Continental Airlines, Inc.
Systems Engineering
600 Jefferson Blvd
Houston, TX 77002

Subject: B767 Engine Fuel Feed Tube and Front Spar Fitting Electrical Bonding Test – Proposed Rule

Reference: A/ Rules Docket No. FAA-2004-19680
B/ Boeing Service Bulletins 767-28A0071 & 767-28A0072
C/ NPRM Docket No. 2004-NM-215-AD

FIGURE 3

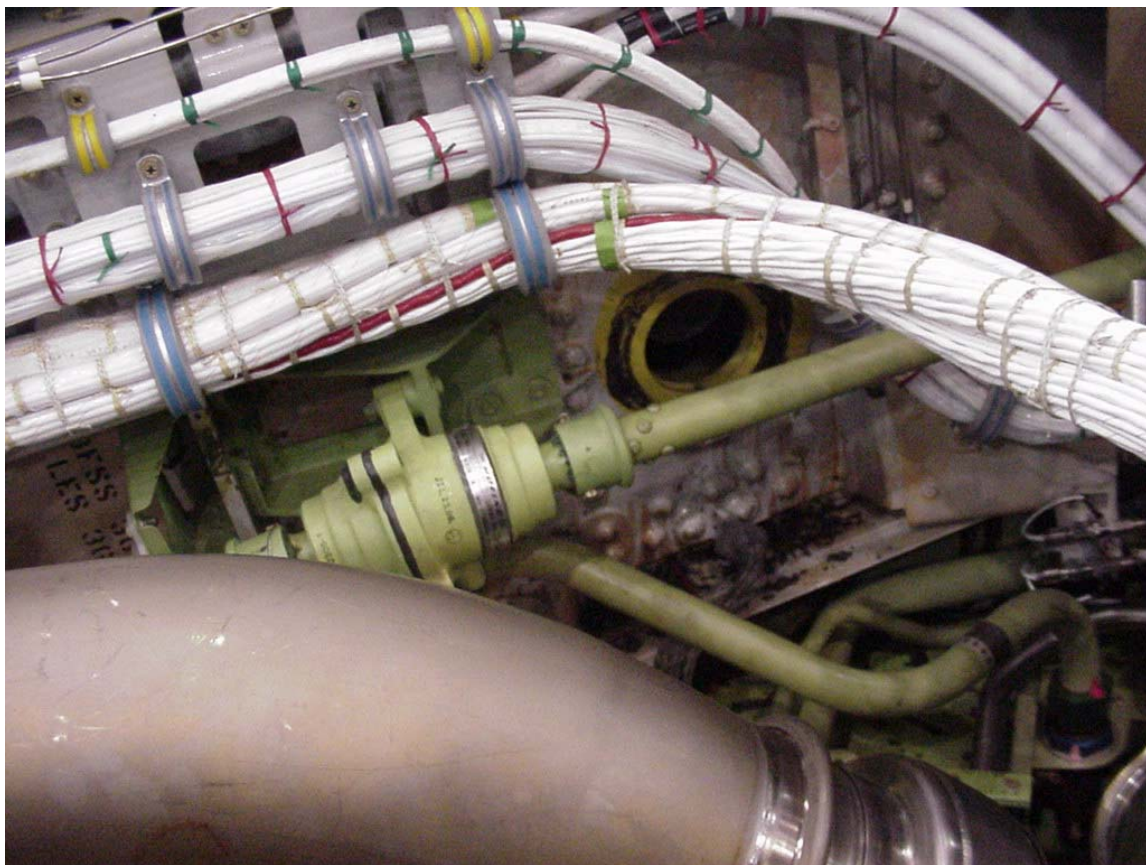
- The preparation of the mating surface area on the dry bay side of the front spar for bonding requires the usage of a stainless steel rotary brush. Upon the completion of this initial clean up and due to the removal by the steel brush of excess aluminum material from the spar, the flap or shot peening of the cleaned area is required. This mating surface area preparation is almost impossible to be done for the following reasons:

- There is a high possibility of damaging the mating surface area by the usage of a stainless steel rotary brush due to the difficulty controlling the cleaning process or the removal amount, or depth of the aluminum material.

- The usage of a stainless steel rotary brush in the front spar area would create and introduce unwelcome contamination in the area and in the fuel tank

- The steel rotary brush when attached to an electrical motor tool would create a fire hazard condition. The front spar area has been classified as a fuel vapor area.

- The current flap or shot peen equipment cannot fit properly in this area due to the accessibility.
 - The current flap or shop peen tools are equipped with an electrical motor that would create a fire hazard condition. The front spar area is classified as a fuel vapor area.

- These alternate rework instructions were evaluated and validated during the accomplishment of the ref. /B/ bulletins on the Continental Airline's airplane. Refer to the attached figures, one through four, that show the affected areas on the front spar.

- The preparation of the mating surface area on the dry bay side of the front spar for bonding should be accomplished by the Cleaning Procedures 1, 2 or 3 of the Boeing Standard Wiring Practices Manual, (BSWPM), section 20-20-00. The cleaning should be accomplished by the usage of fine abrasive material, 100 grit or finer, that would remove the minimum amount of aluminum, not to exceed 0.0010 inch.
